SNE CORPORATION
WAUSAU, WISCONSIN

ENGINEERING REPORT
PRESENTING
A SITE INVESTIGATION PLAN
FOR
PENTACHLOROPHENOL

PROJECT #509-1
DECEMBER 1984

SITE PLAN

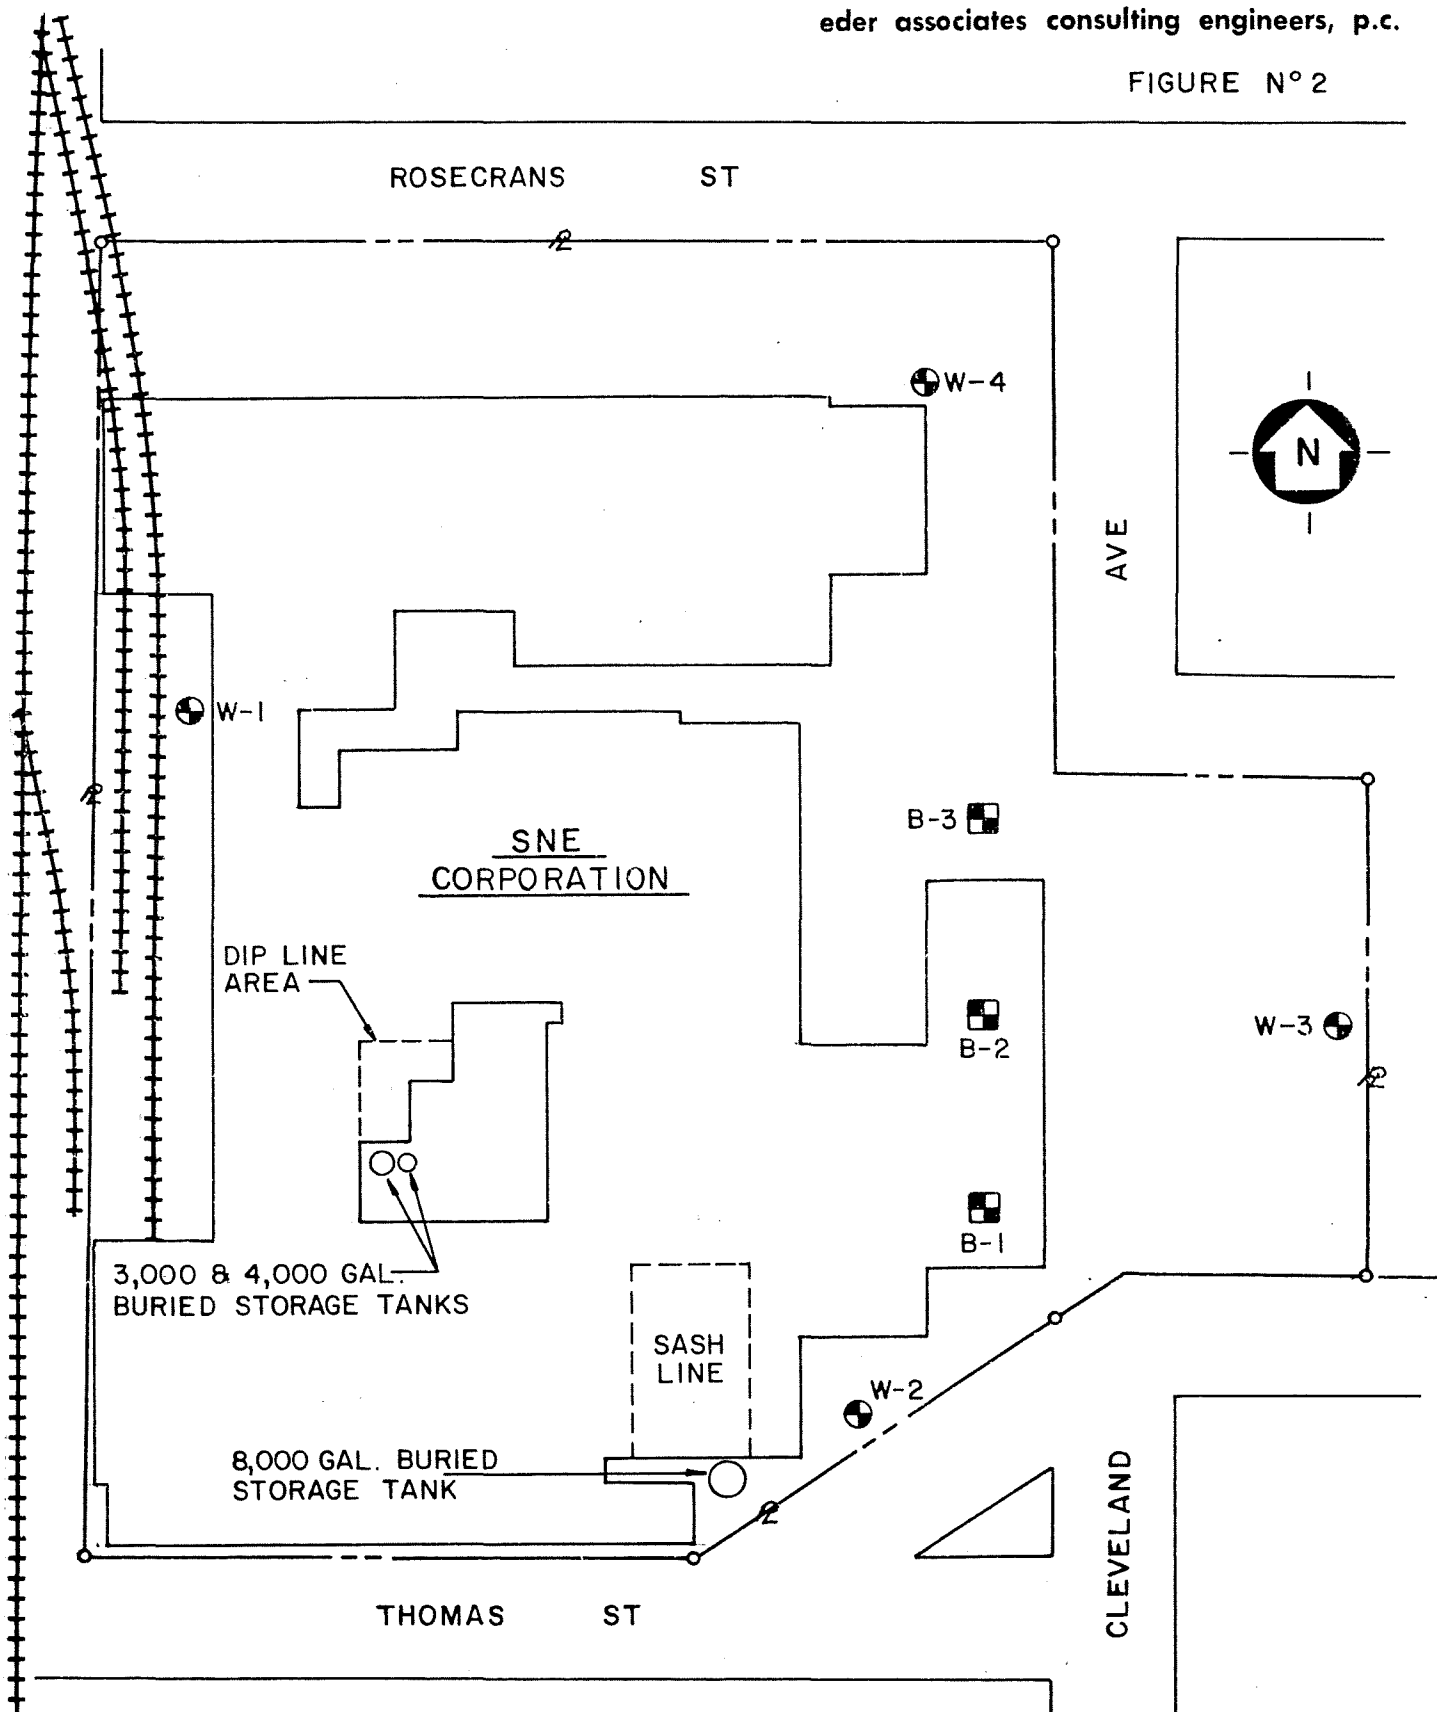
At least 1 well should be installed near dip track 1/2 in 4000 gal buried tank.
